TransGrid Revenue Proposal 2023-28

# **REVIEW OF RIT-T PROJECT: MANAGING RISK ON LINE 86 (PUBLIC VERSION)**

Report prepared for:  
**AUSTRALIAN ENERGY  
REGULATOR**  
August 2022

Figure 3.3: Summary of NPV analysis for selected options

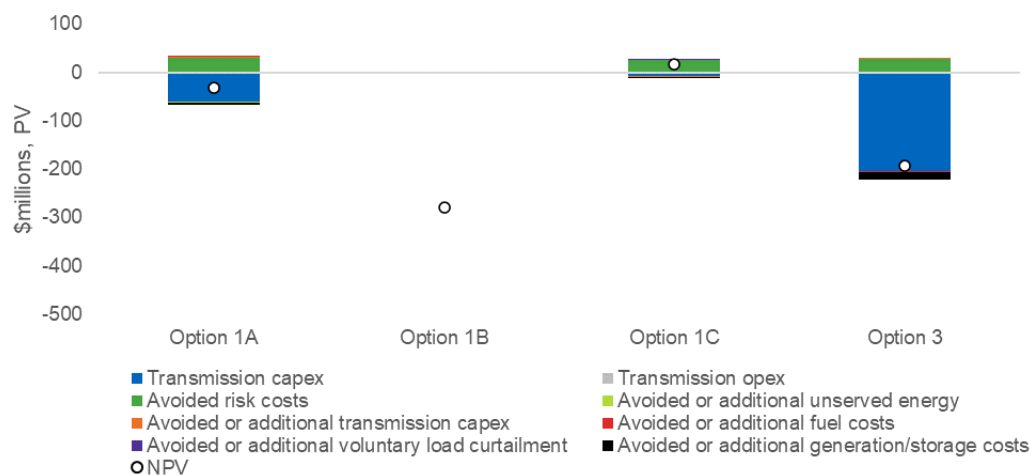
153. When we make adjustment for these factors, the benefits attributable to this project cause the NPV to go marginally negative. However, when a further adjustment is made to remove the costs of stage 2, noting the uncertainty around cost and timing of this stage (and that there is no need to commit this stage now), the NPV returns to a positive value in the order of \$2m.

155. We were not able to readily account for the over-estimate of safety related bushfire costs to reasonably apply the appropriate disproportionality factor, due to the bushfire consequence cost being a single hard-coded figure. We recognise that the safety related costs form a proportion of these costs, however we were not able to assign a proportion of these costs with a reasonable level of confidence.
